Re: Revised Work Plan for Additional Site Investigation
Former Chevron Service Station 9-0517
3900 Piedmont Avenue
Oakland, California
Case No. RO0000138

RESPONSES TO TECHNICAL COMMENTS

Subject: Request for Work Plan; Fuel Leak Case No. RO0000138; Global ID # T0600102248;
Chevron #9-0517 / Homestead Federal Savings, 3900 Piedmont Avenue, Oakland CA
94610

figure 2
 SITE PLAN
 FORMER CHEVRON SERVICE STATION 9-0517
 3900 PIEDMONT AVENUE
 Oakland, California

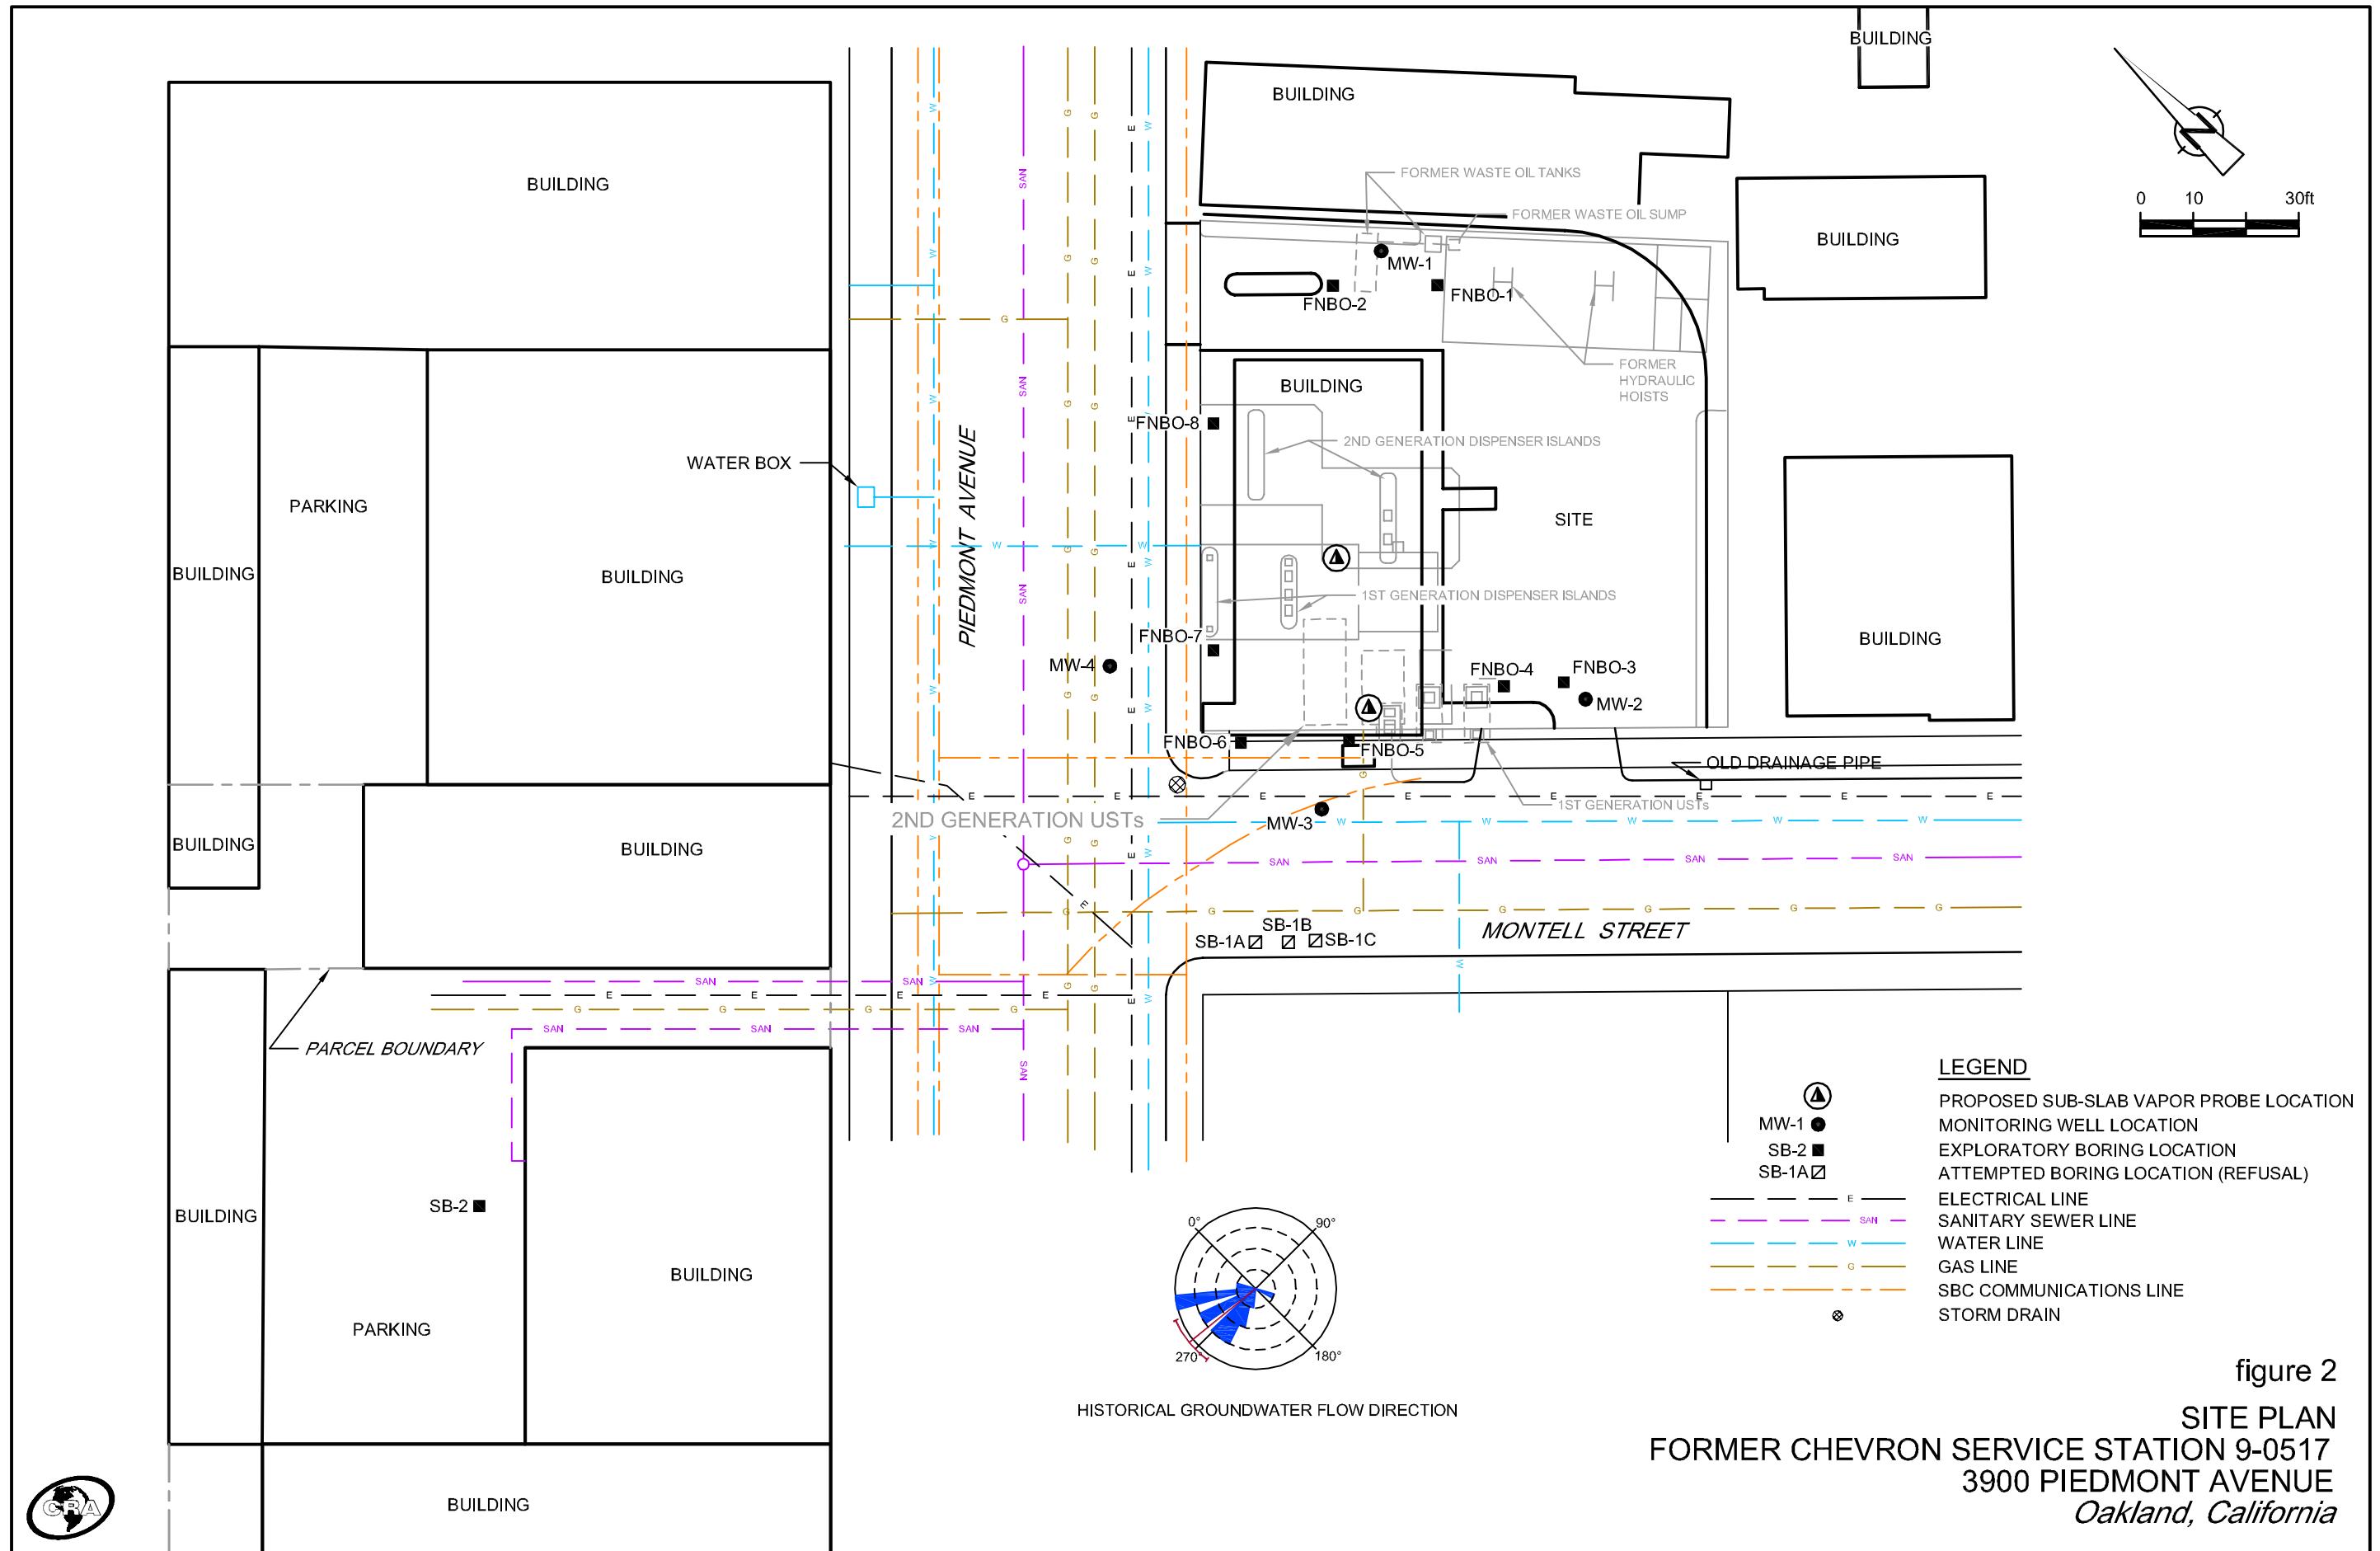
ACEH stated that the downgradient extent of impacted groundwater has not been fully evaluated, as only offsite boring SB-2 has been drilled. ACEH further stated that, because the downgradient extent of the groundwater plume was undetermined across Piedmont Avenue, it

may also be appropriate to dovetail a vapor intrusion investigation to building(s) across Piedmont Avenue as a partial alternative to full plume delineation.

CRA Response: Most of the previously planned offsite borings could not be advanced due to the numerous utility lines in the surrounding streets (see Figure 2), drilling refusal, and the fact that the City of Oakland does not allow drilling in the sidewalk. The presence of numerous large buildings also limits the available space. A grab-groundwater sample collected from downgradient boring SB-2 contained a low concentration of total petroleum hydrocarbons as gasoline (TPHg), but no benzene. As described in the closure request, area drinking water is provided by East Bay Municipal Utility District (EBMUD) from distant surface water sources, no wells were identified within 2,000 feet downgradient, and the nearest surface water body is Glen Echo Creek approximately 400 feet upgradient. Therefore, although the downgradient extent of hydrocarbons in groundwater has not been delineated to standard laboratory reporting limits, it is our opinion that it has been delineated to the extent necessary to determine whether the concentrations in groundwater pose a risk to current or potential future receptors. Since previous work has shown that no potential groundwater receptors are at risk, and the plume is degrading, groundwater is adequately delineated for the purposes of determining risk to receptors. Thus, the only remaining potential concern is vapor intrusion into the offsite buildings from underlying groundwater. The proposed onsite sub-slab vapor sampling will evaluate any potential vapor intrusion issues directly above the former source areas (worst-case scenario). Therefore, the sub-slab results will be used to determine if potential offsite vapor intrusion is a significant concern that warrants further evaluation.

To evaluate potential vapor intrusion risk, CRA proposes to install and sample two sub-slab vapor probes inside the building. The approximate proposed sub-slab vapor probe locations are shown on Figure 2. In addition, samples of air inside the building and ambient air outside the building will also be collected. The sub-slab sampling results will be compared to the indoor and ambient air results to evaluate whether a complete pathway exists for vapor intrusion into the building. All work will be conducted in accordance with the Department of Toxic Substances Control (DTSC) December 15, 2004 *Guidance for the Evaluation and Mitigation of Subsurface Vapor Intrusion to Indoor Air (Revised February 2005)*. The details of the proposed work are presented in the sections below.

CRA proposes to install two sub-slab vapor probes within the building, per the guidance the desired locations are near the center of the slab and in the likely area of highest residual impacts (Figure 2). Utilities entering the building will be identified and marked, and any internal locations where utilities penetrate the slab (e.g. furnace, water heater, circuit breaker box, and water or sewer lines) will be identified and avoided. The final probe locations will be determined based on interior access and the presence of utilities or other subsurface obstructions.
